**KNOXVILLE/KNOX COUNTY METROPOLITAN PLANNING COMMISSION  
SUBDIVISION REPORT - CONCEPT/USE ON REVIEW**

▶ **FILE #:** 1-SE-15-C  
1-I-15-UR

▶ **SUBDIVISION:** MOURFIELD ROAD SUBDIVISION  
▶ **APPLICANT/DEVELOPER:** ERIC MOSELEY  
**OWNER(S):** Volunteer Development

CONCEPT OVERALL PLAN

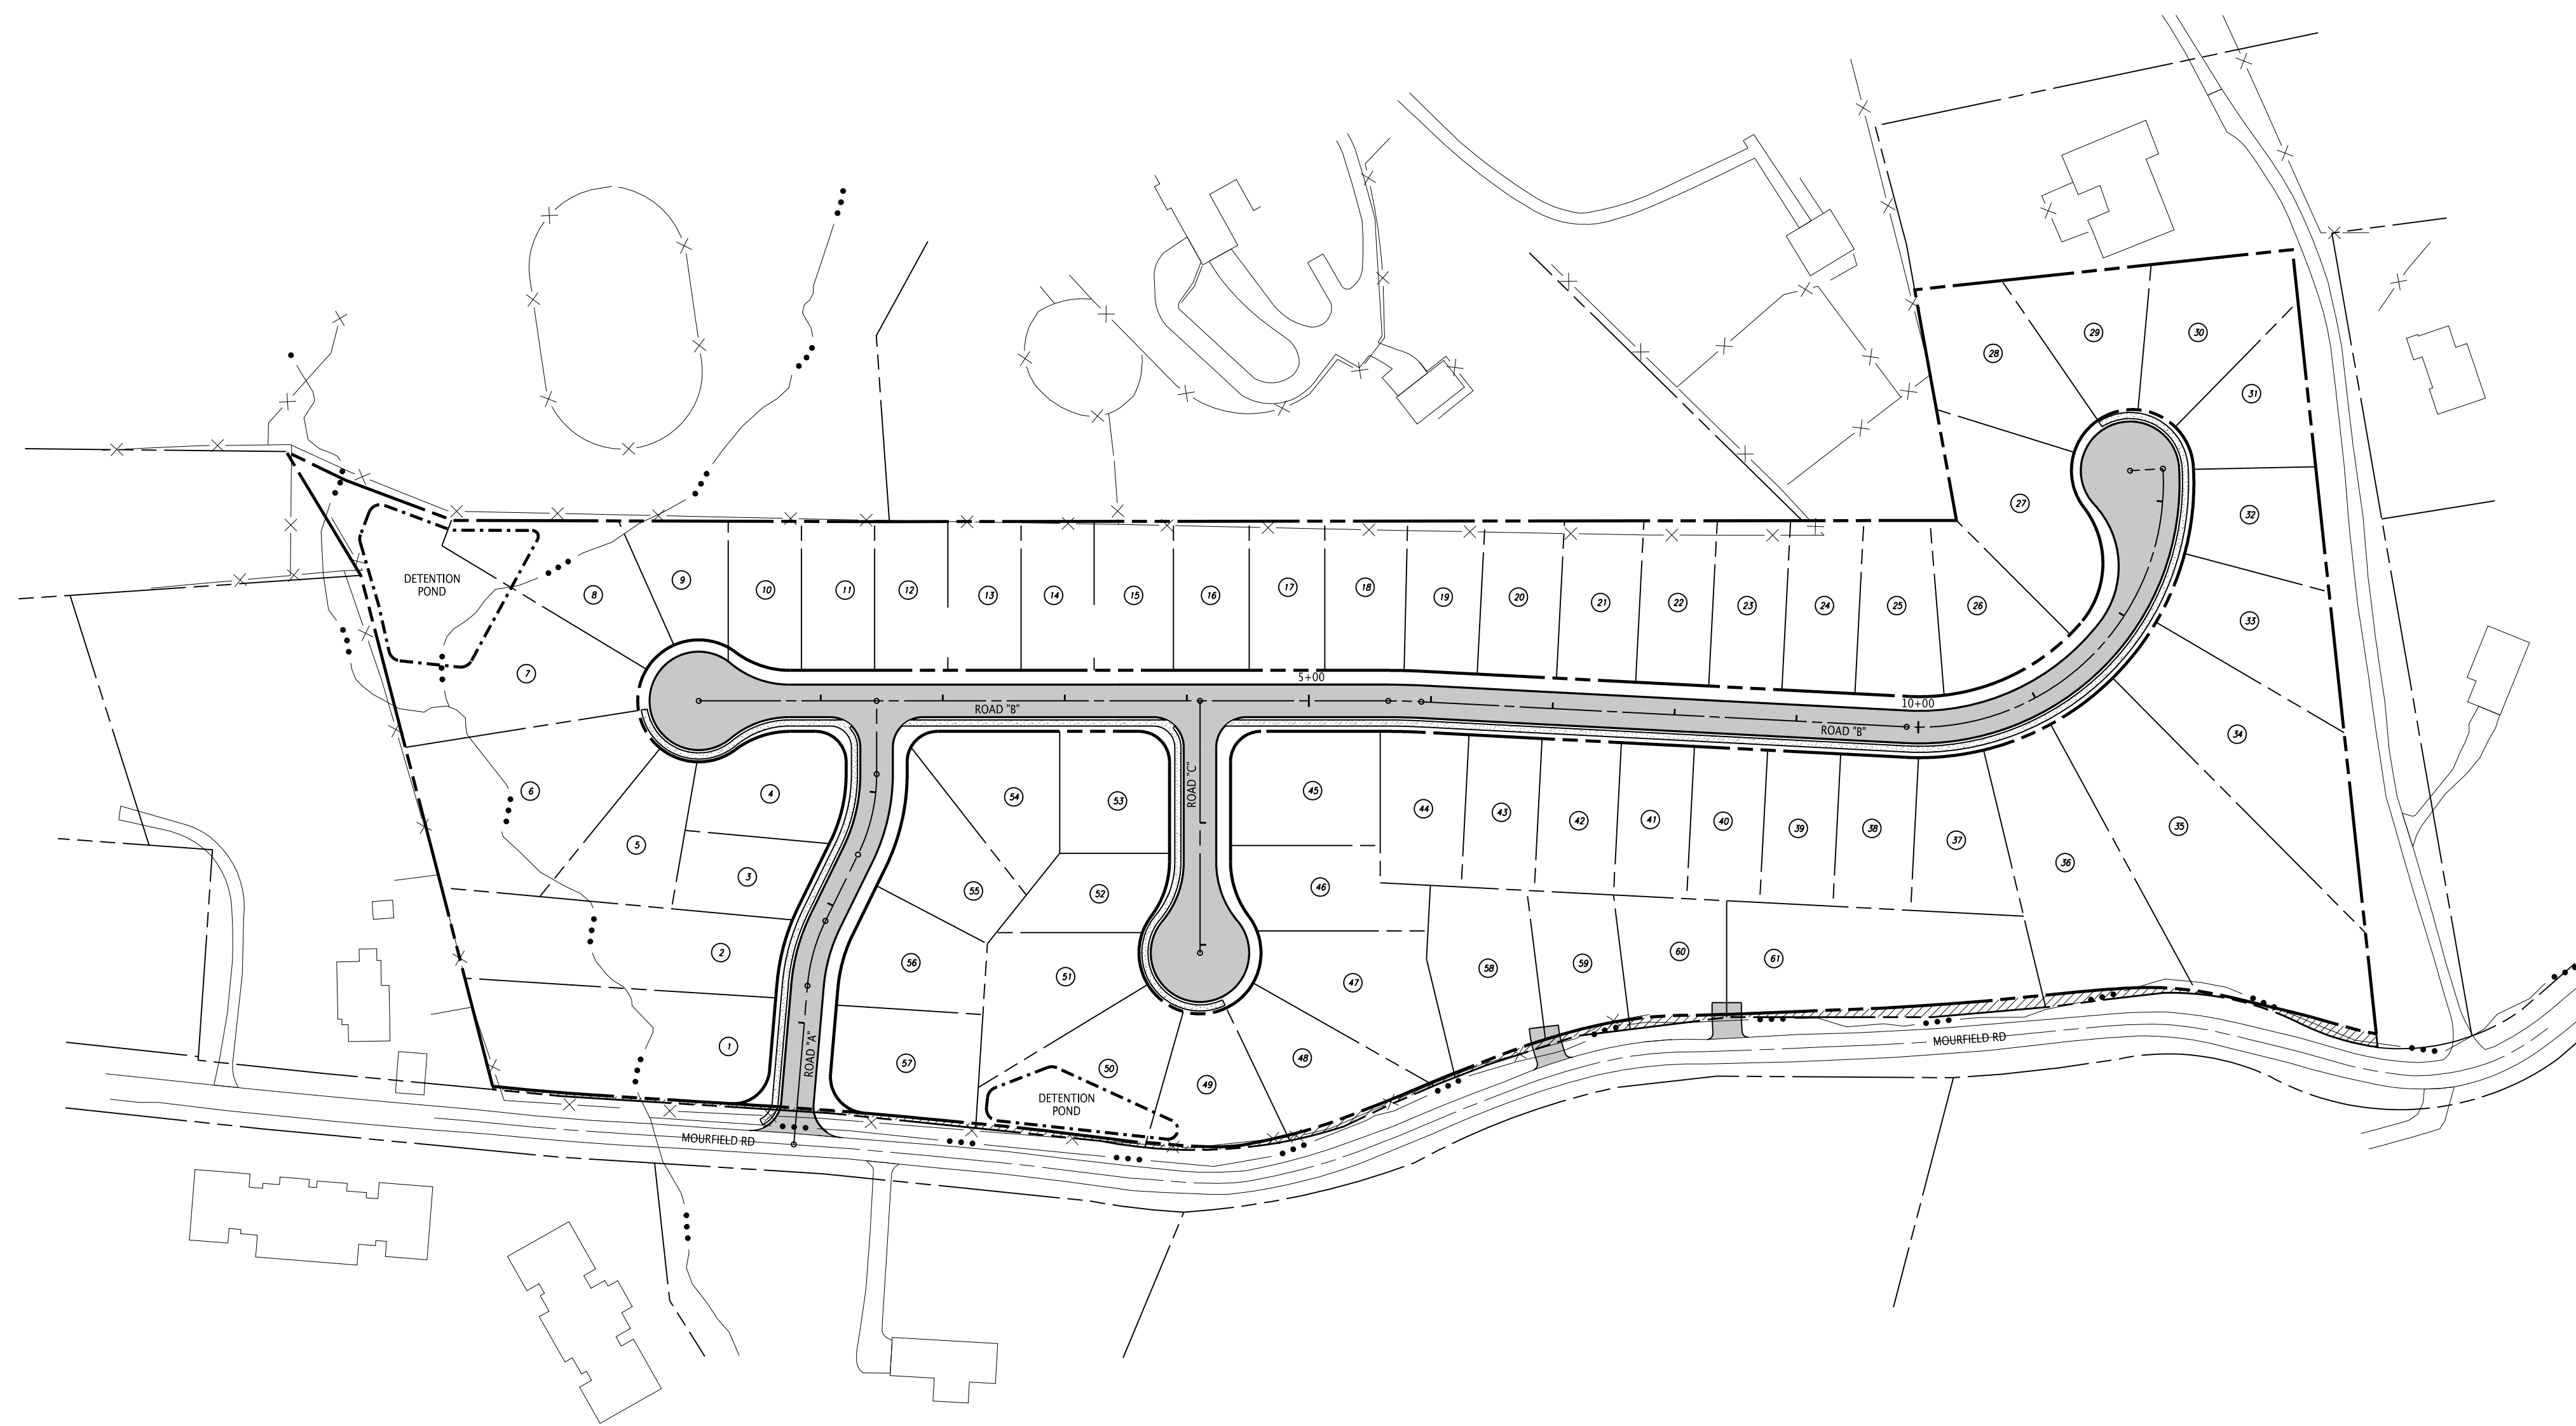
Staff has concerns with this plan with regard to sight distance. The plan calls for the main entrance road and two driveways to access Mourfield Rd. Staff has not been able to verify that either location has the required 300 feet of sight distance. The applicant's engineer believes the sight distance can be provided at the locations in question. Staff has included a number of conditions in this recommendation that specifically address the sight distance question. We have stated that if the sight distance cannot be provided as required, then a new concept plan will be required. The verification of sight distance will be required to be completed before a grading permit is issued for this project.

A second area of concern is the proposed stream buffer along the creek that passes across the northern portion of the site. The buffer is required to be a minimum of 50' wide on each side of the creek bank. Due to the required width of the stream buffer, lot one appears to be unbuildable. The applicant believes the lot is buildable. This is a matter that will have to be resolved at the design plan stage when the detailed grading and drainage plans are reviewed. This may become a non-issue because a detention basin may have to be located in this area.

At the concept plan level the storm drainage plan typically consists of a notation on the plan where the proposed detention basins will be located. After the concept plan is approved the County Engineering Dept. will receive a detailed grading and drainage plan for their review. In this case, the detention basin shown in the northeast corner of the site will most likely need to be relocated because it would be difficult to get all of the lots to drain to this location. Relocating the detention basin may have an impact on the final lot count.

- There are safety issues with multiple driveways having direct access onto Mourfield Rd. For 30 mph speed, a minimum sight distance of 300-feet has to be available before access is approved. Private driveways should not be allowed to access Mourfield from the new development. Especially backing of a car onto the roadway from a private residence.

- It is doubtful that a sight distance of 300-feet is available for the main entrance. This should be proven in the field prior to MPC approval.
- The Knox County regulations (62-60, pg 35) state that the local street maximum grade is 12%. Road "B" on the drawings shows an existing grade of 15%. Road A shows a grade of 12.5%. They should not be approved for greater than 12% unless there is a valid reason for doing so. If the allowable grade has to be raised to 15% to make the subdivision developable, development should not be allowed. Raising from 12% to 15% should be the exception and not the norm. I know that the regulations say that for exceptions it can be raised to 15%. If 15% was the intent, they would not have listed 12% as the maximum grade in the regulations.

- The concept drawing and the preliminary construction drawing are not realistic in that they depict a detention pond being located at the northern corner of the site within two streams that are converging. One has been classified as a wet weather stream. The Detention Pond cannot be located at that particular location as the stormwater regulations DO NOT allow the Detention Pond to be located within an existing stream, much less two streams. Waters flowing from the site have to be collected before they are discharged to waters off-site. Off-site streams cannot be directed through new stormwater detention structures, therefore the current locations of the detention basins are not realistic or optimal.

- Stormwater regulation require ALL stormwater from the development to be collected separately from off-site water before being discharged off-site. This is not the case in these plans as water is NOT shown as being collected at the southern part of the site before being discharged off-site. For some reason, detention ponds are located upstream of the lowest point on the site. The subdivision entrance is located close to where a detention pond would probably be required, therefore the subdivision entrance location is not realistic which also affects the sight distance that can be achieved.

- Lot #'s 1, 2, 6, 7, and 8 show the 50-foot buffer. They are not practical for building on if the buffer is honored. The plan is not realistic in this area.

▶ **APPROVE** variances 1 - 5 because the site's topography restricts compliance with the Subdivision Regulations, and the proposed variances will not create a traffic hazard.

2. Certification on the design plan and final plat by the applicant's surveyor that there is 300 feet of sight distance in both directions on Mourfield Rd. from the proposed subdivision entrance road and from each of the proposed driveways. Approval of all lots is contingent on all these locations being field verified by the Knox County Dept., of Engineering and Public Works for adequate sight distance. Should any of the proposed access locations onto Mourfield Rd. not meet the minimum required sight distance, a new concept plan will be required for the affected lots

3. Prior to obtaining a grading permit provide the Knox County Dept. of Engineering a road profile of Mourfield Rd. that includes the proposed locations of the driveways shown on lots 58-61 and the proposed subdivision entrance road

6. Conducting a stream determination study to determine if the existing creeks/drainage ways are waters of the State and require stream buffers and if they will effect the location of the proposed detention basins

**GRADING PLAN**

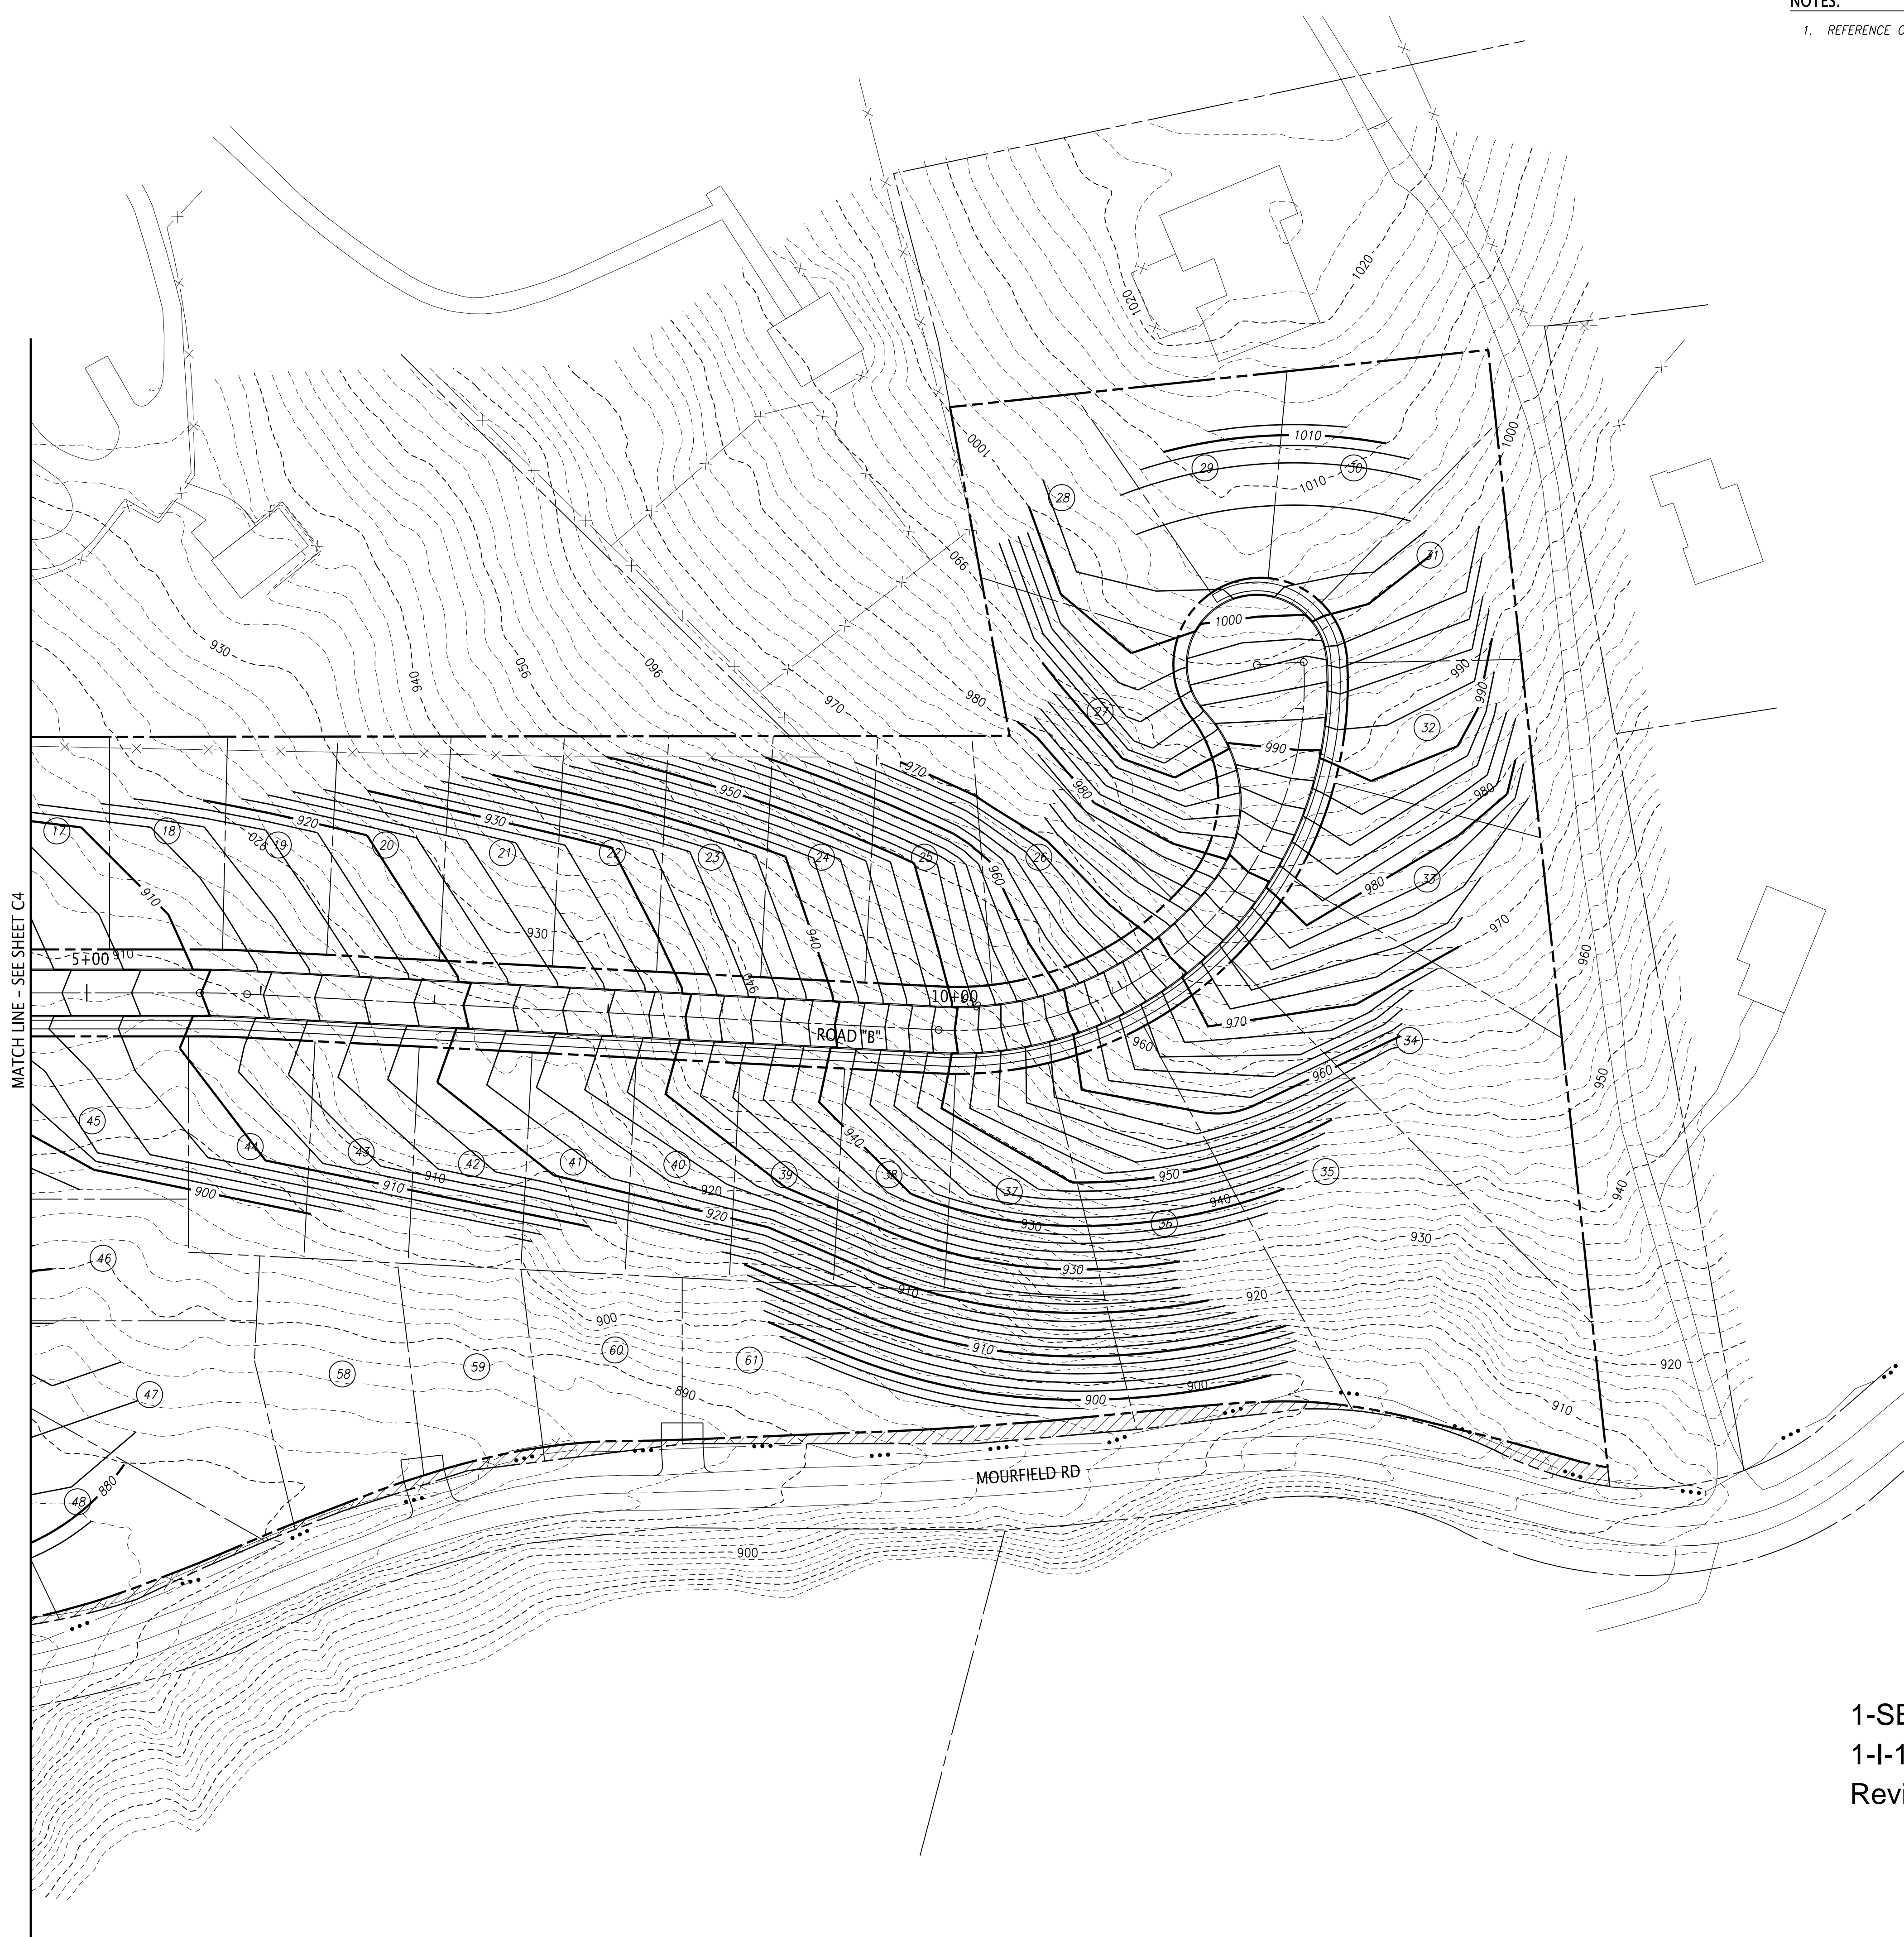
- Guidelines were passed in 2012 for the "Hillside & Ridgetop Protection Area Development Standards. These are guidelines for developments in which the slopes are greater than 16%. The guidelines should be honored by the developer as slopes on the northern and southern sides of Road B are very steep. Measures should be enforced to minimize sloughing off of embankments and stormwater erosion velocities upstream and downstream of Road B. There are enough examples of slope failure in the report to understand that Knox County doesn't want to keep approving of developments without doing their due diligence first.

- Lots 35 – 39 are bisected by fairly long and steep slopes that would require very controlled erosion control structures to be put into place prior to construction as they are adjacent to the drainage channel for Mourfield Road. With high stormwater velocities being realized in the drainage channel on Mourfield Rd, any sediment that enters the drainage channel will be transported into the creek immediately. As a side note, these are not very good building sites for the houses that would eventually inhabit the lots.

- The size of the detention basins as shown are not realistic for the current stormwater regulations which require it to be sized for a 2-yr to a 100-year storm event. Property along Mourfield road is a very steep and has very fast times of concentration, therefore receive high volumes of water very fast. The size of detention basins that are shown are conceptual, but still not realistic.
